Access Compliance Report

Public Rights-of-Way

(Curb Ramps)

Intersection ID: 29711	Main Street: GATESVILLE_LN	Cross Street: ROBESON_CREEK_DR	Location: W
ADA ID: 161D5D787791	Ramp Type: PerpDiag	Initial Pass/Fail: Fail	Overall Compliance: No
Severity Score: 8.75			
Codes/Mitigation Info/Possible Solution		Field Measurements/Component Compliance

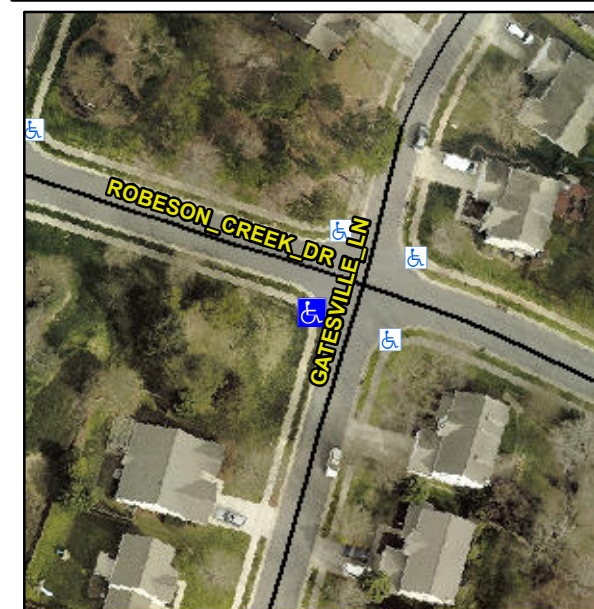
Compliance	Description	Data	Compliance	Description	Data
N/A	Ramp Length (in)	44.0	Yes	Ramp Slope (%)	7.2
No	Ramp Width (in)	41.0	Yes	Ramp XSlope (%)	1.0
N/A	Flare Type LT	N/A	N/A	Flare Type RT	N/A
N/A	Flare Slope LT (%)	N/A	N/A	Flare Slope RT (%)	N/A
N/A	Flare Traversable LT?	N/A	N/A	Flare Traversable RT?	N/A
N/A	Landing Length (in)	N/A	N/A	DWS Provided?	N/A
N/A	Landing Width (in)	N/A	N/A	DWS Contrast?	N/A
N/A	Landing Slope (%)	N/A	N/A	DWS Length (in)	N/A
N/A	Landing X Slope (%)	N/A	N/A	DWS Full Width?	N/A
N/A	Landing Curb? (Y/N)	N/A	N/A	DWS Offset (in)	N/A
N/A	Shared Landing?	N/A			
N/A	Gutter Ponding?	N/A	N/A	Gutter Slope (%)	N/A
N/A	Gutter Lip Ht (in)	N/A	N/A	Gutter X Slope (%)	N/A
N/A	Painted X Walk1?	No	N/A	Painted X Walk2?	No
	X Walk 1 Direction	To SE		X Walk 2 Direction	To NE
N/A	X Walk 1 Width (in)	N/A	N/A	X Walk 2 Width (in)	N/A
	X Walk 1 Slope (%)	2.2		X Walk 2 Slope (%)	1.6
	X Walk 1 X Slope (%)	0.6		X Walk 2 X Slope (%)	0.8

N/A	Ramp inside XWalk1?	N/A	N/A	Ramp inside XWalk2?	N/A
	Road Slope (%)	2.7	N/A	Clear Space?	N/A
	Road X Slope (%)	0.5	N/A	Clear Space to XWalk (in)	N/A
N/A	Any Obstructions?	N/A	N/A	Storm Grate/Utility Hazard?	N/A
	Obstruction Type			Storm Grate/Utility Type	
		N/A			N/A
			Yes	Surface Condition? (G/P)	Good

Remove & Replace Curb Ramp With Two New Directional Ramps or Equivalent.
